## SITE PLAN REVIEW AND APPEARANCE BOARD

### 7<sup>th</sup> Avenue Banyan

Meeting	File No.	Application Type
November 30, 2022	2022-092-SPF-SPR-CL5	Class V Site Plan with Waiver
Applicant / Property Owner		Authorized Agent
West Atlantic Development Company, LLC		John W. Szerdi, LEED AP of Living Designs Group Florida Architects, Inc.

Provide a recommendation to the City Commission for a CBD waiver request associated with a Class V Site Plan to allow the use of the Porch frontage type, in place of the required Storefront or Arcade with Storefront frontage type, associated with the construction of a 16,298 square foot, three-story mixed-use building at 625, 633, and 645 West Atlantic Avenue, also known as 7<sup>th</sup> Avenue Banyan.

Figure 4.4.13-E-3 Porch Frontage Type

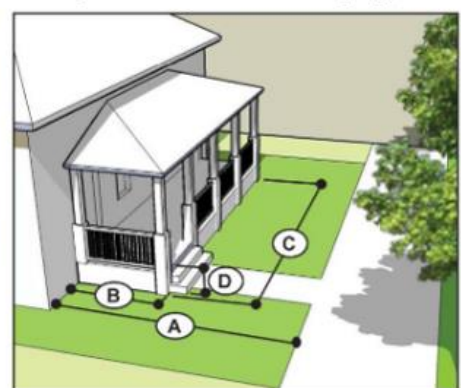
The justification for proposing a Porch in place of a Storefront or Arcade with Storefront is outlined in the applicant's justification statement. The applicant states that due to FDOT's right-of-way restrictions, the change in grade, and the expanse of Storefront glass facing direct sun, a Porch frontage type is most suitable as it is accommodated outside of FDOT's right-of-way, addresses the change in grade, and provides shade and UV protection for the merchants and pedestrians. The image below dimensions the streetscape and the height of the steps, which is one foot above the sidewalk.

While the Porch frontage type is most commonly associated with residential uses, the CBD regulations allow the Porch to be incorporated with commercial uses as well; however, it is not identified for use along Required Retail Frontage streets. The CBD code anticipates a more traditional main street and limits the types of uses and frontage types to promote a superior pedestrian experience and reinforce the relationship between the pedestrians and ground floor commercial space. Consideration should be given as to whether the Porch frontage type

provides a better option for absorbing the change in grade across the site, and whether the increase in elevation and railings create an inferior pedestrian experience by separating the pedestrian realm and impacting the marketability of the retail spaces.
